TRANSMITTAL COVER SHEET

DATE: 25 June 2024
TO: ALL PLAN HOLDERS OF RECORD
FROM: HUNTER SWATEK, AIA, PROJECT MANAGER
PROJECT: RAINBOW CITY RECREATION CENTER
GMC PROJECT NO. ABHM230021
RE: ADDENDUM NO. 4 AND
ACKNOWLEDGEMENT OF RECEIPT OF ADDENDUM NO. 4

ADDENDUM NUMBER 04

**PROJECT: RAINBOW CITY RECREATION CENTER
GM&C PROJECT NO. ABHM230021**

D1 GYM ELEVATION - EAST
 SCAL 3/16" = 1'-0"
 E:

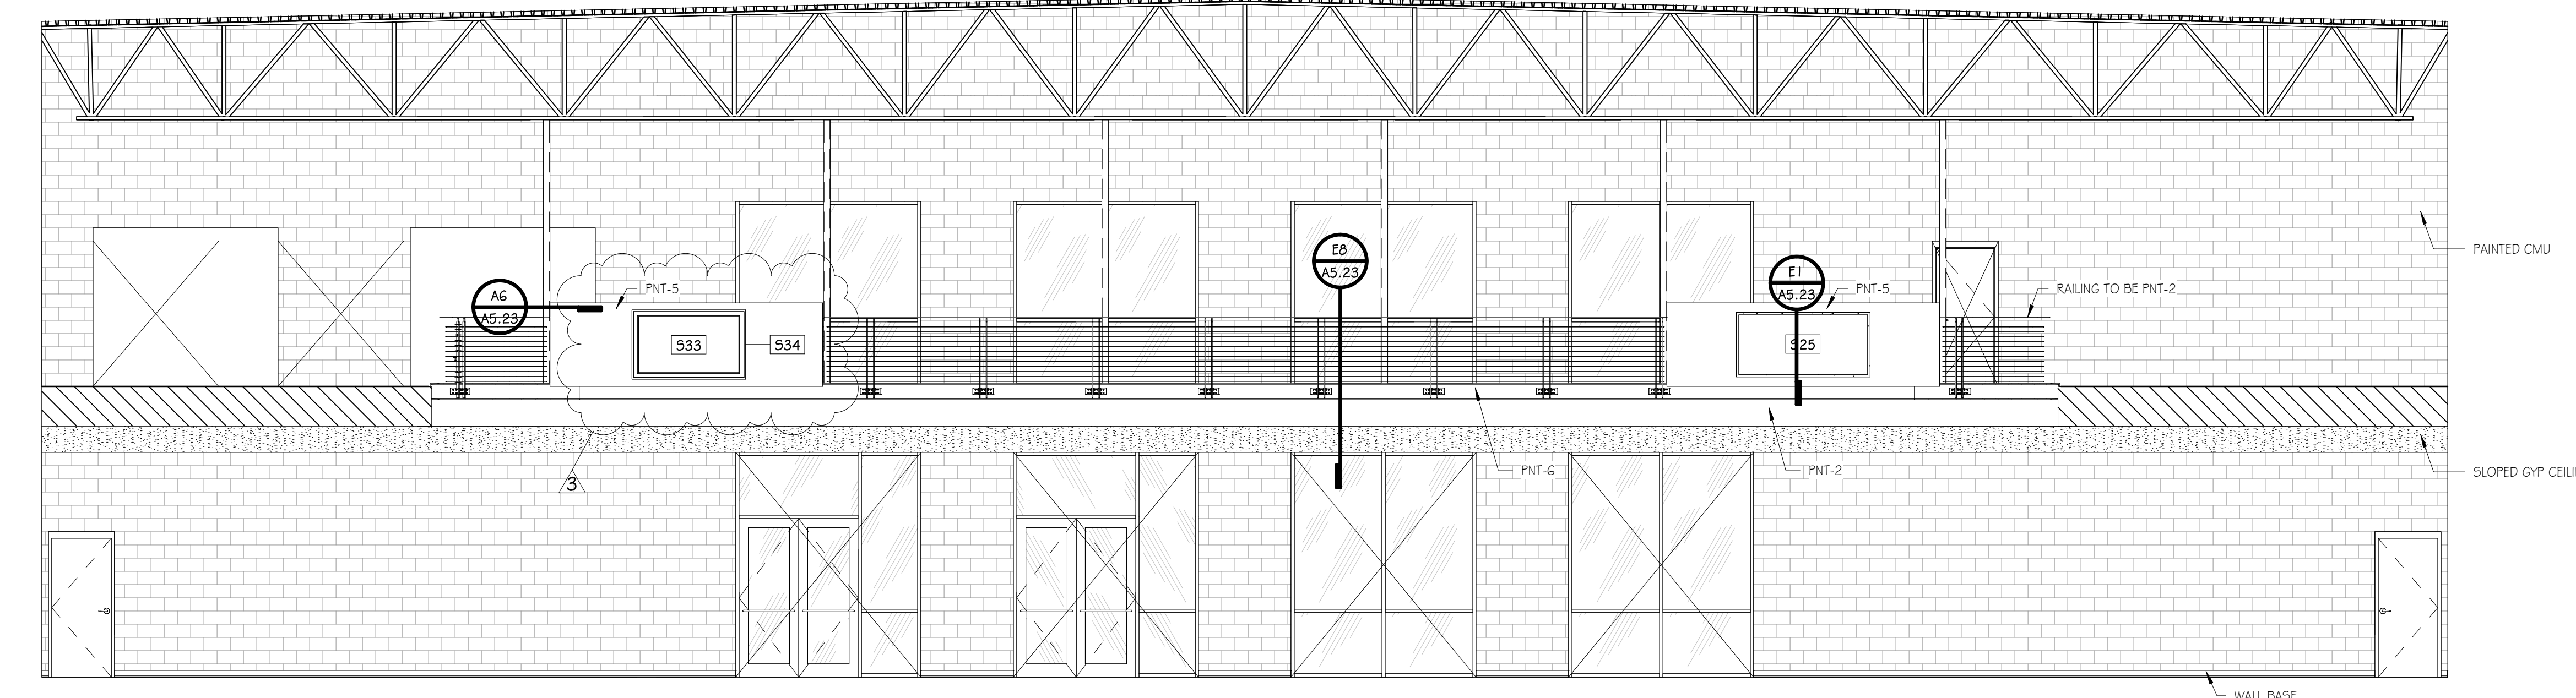
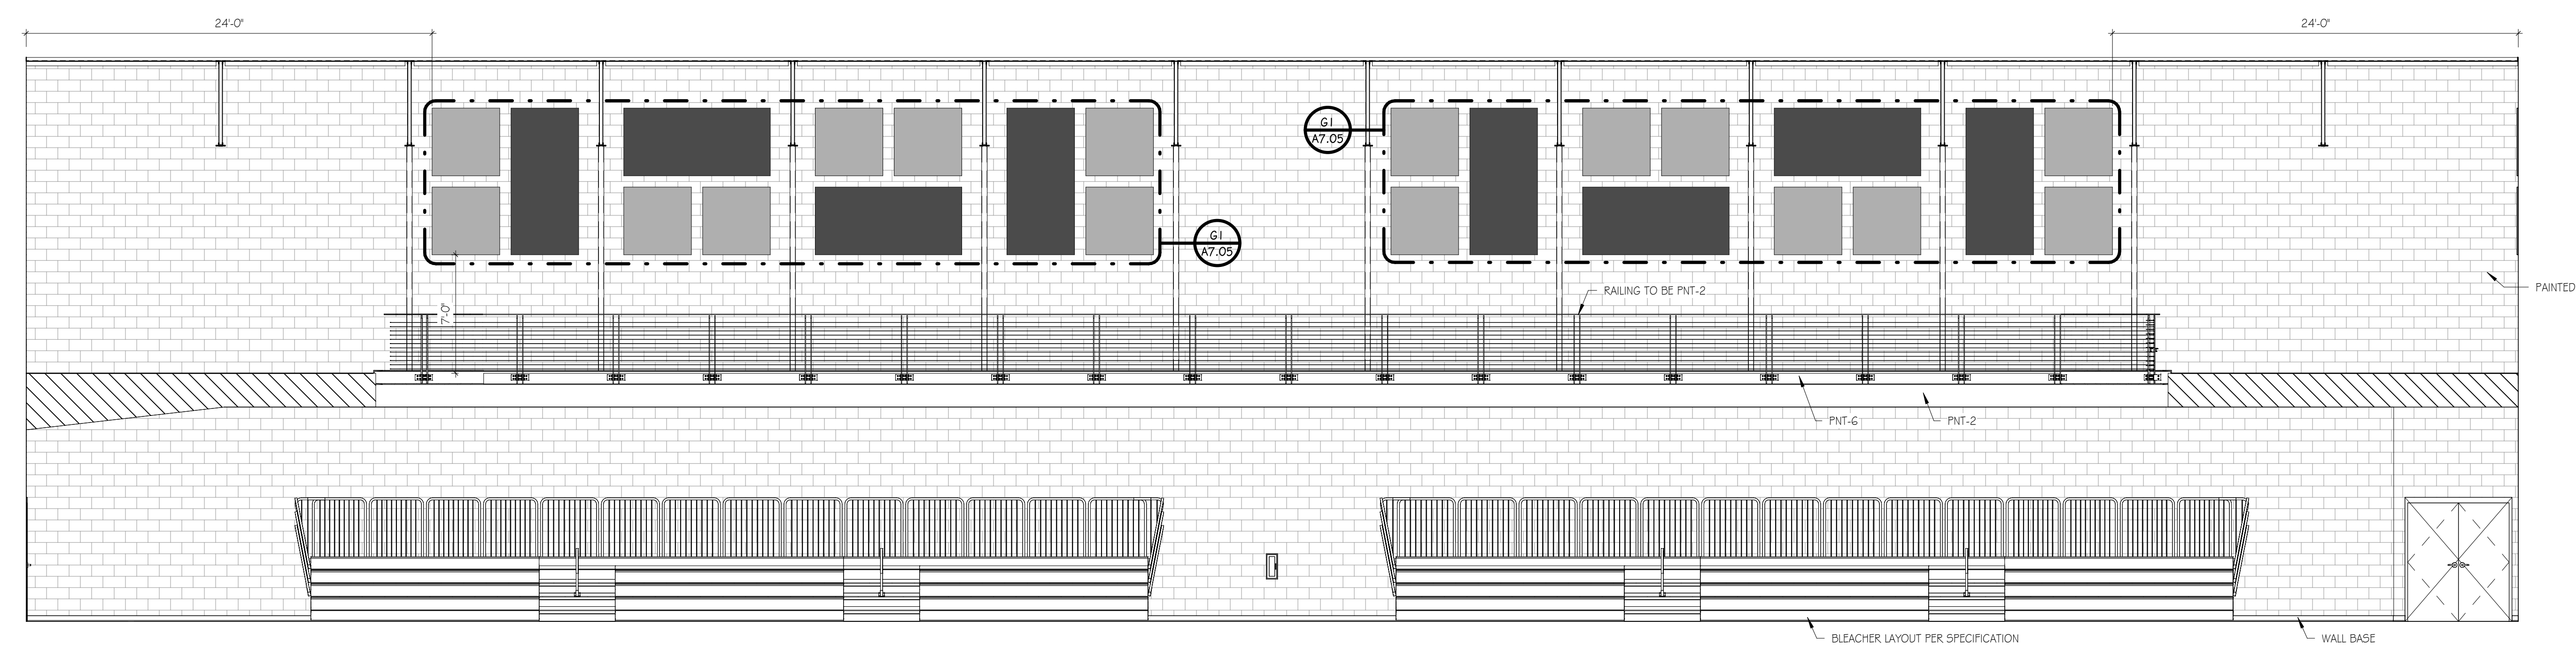
- a. ADDED TV Enclosure
- F. **A7.06** – Gym Interior
 - a. ADDED TV Enclosure
- G. **A7.07** – Interiors Multi-Purpose
 - a. REVISED Acoustics Pattern
- H. **A9.04** – Amphitheatre
